YUCCA MOUNTAIN - REQUEST FOR ADDITIONAL INFORMATION - SAFETY
EVALUATION REPORT, VOLUME 3, CHAPTER 2.2.1.2.1 (SCENARIO ANALYSIS),
6TH SET (DEPARTMENT OF ENERGY'S SAFETY ANALYSIS REPORT SECTION 2.2,
TABLE 2.2-5)

Response to RAI Volume 3, Chapter 2.2.1.2.1, Set 6, Number 1

RAI Volume 3, Postclosure Chapter 2.2.1.2.1, Sixth Set, Number 1:

Figure 1. Illustration of the Location of the Tested Samples and Testing Direction Compared with Location and Direction of the Maximum Induced Thermal Stresses

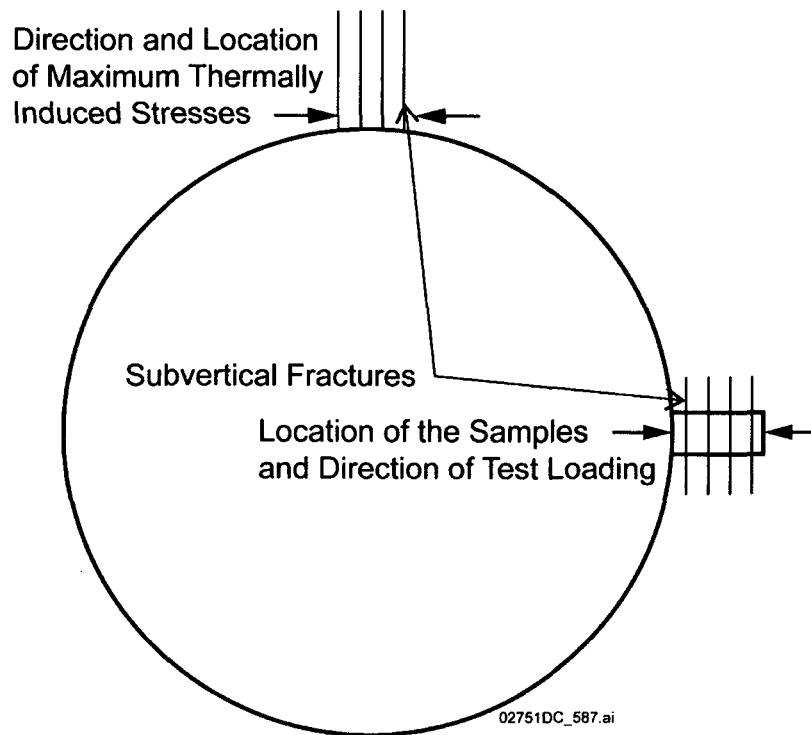
Demonstrate how the Voronoi block model appropriately represents the characteristics of the Topopah Spring lower lithophysal tuff, such that the potential for drift collapse is not underestimated.

Basis: In the UDEC-Voronoi model, DOE concludes that 30 cm average block diameters with randomly oriented sides are representative of the randomly oriented internal discontinuities within the Topopah Spring lower lithophysal tuff. DOE characterizes the Topopah Spring lower lithophysal tuff as having primarily vertical fractures with spacings on order of several centimeters (BSC 2004, section 7.3.2). Although DOE concludes that the presence of lithophysal voids creates a generally isotropic rock mass (DOE, 2009, RAI-1), DOE did not provide information to show how such voids homogenized the potential effects of a vertical anisotropy in the rock mass.

The 11.5-inch-diameter samples of Tptpl illustrated in Figure 1 were taken from the horizontal boreholes drilled in the drift springline. They were tested by applying the load in the direction aligned with the core axis, which corresponds to the horizontal *in situ* direction (i.e., perpendicular to the subvertical fractures). The maximum thermally induced stresses would be horizontal in the drift crown (Figure 1), and in the same direction in which the samples were tested. The six test results on the samples taken in the Tptpl (BSC 2004, Table E-9) are generally in good agreement with, or even exceed, the strength compared to the mean curve of the strength versus stiffness relation (BSC 2004, Figure E-13) for the lithophysal tuff. Thus, the Voronoi block model that is calibrated to five rock mass categories corresponding to equally spaced points on the mean curve (BSC 2004, Figure E-13) adequately represents conditions of deformation and damage in the drift crown where the peak thermal stresses will be experienced.
